# Planning Commission Staff Report

March 14, 2012 Item 6.a.

SUBJECT:	PUD-85-08-12D (Site 1), PUD-81-30-86D (Site 2), & P11-0856	
APPLICANT:	Bob Linder / BRE Properties, INC.	
PROPERTY OWNERS:	WP Carey (Site 1) and BRE Properties Inc. (Site 2)	
PURPOSE:	Applications for: (1) two PUD (Planned Unit Development) Development Plan approvals to construct: (a) a mixed-use high- density residential/commercial development containing 251 residential units, 4 live/work units, and approximately 5,700 square feet of retail space at the property located at the southeast corner of Owens Drive and Willow Road (PUD-85-08-12D); and (b) a high-density residential development containing 247 residential units, 4 live/work units, and a .55-acre public park at the property located at the northern corner of Gibraltar Drive and Hacienda Drive (PUD-81-30-86D); and (2) an amendment to the Phase I and Phase II Development Agreements between the City of Pleasanton and Prudential Insurance Company of America to: (a) extend the term of the Development Agreement to five years from the date of approval of the two Development Plans referenced above; and (b) incorporate approval of the development standards and des

Figure 3: Site 2

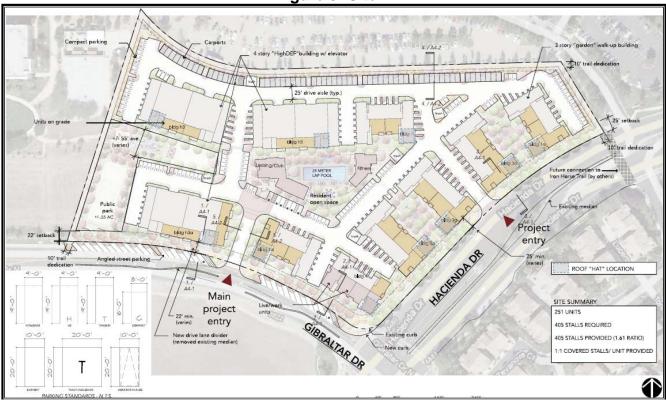
<u>Site Access</u>: There are two vehicular access entrances to the site: one from Hacienda Drive and one from Gibraltar Drive. The entrance on Gibraltar Drive would act as the main entrance to the site. Please refer to Figure 3 below.

Figure 2: Site 1

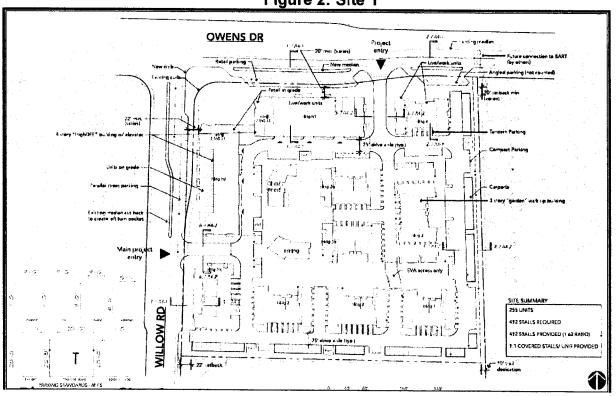
<u>Site Access</u>: There are two vehicular access entrances to the site: one from Willow Road and one from Owens Drive. The entrance on Willow Road would serve as the main entrance to the site. Please refer to Figure 2 below.
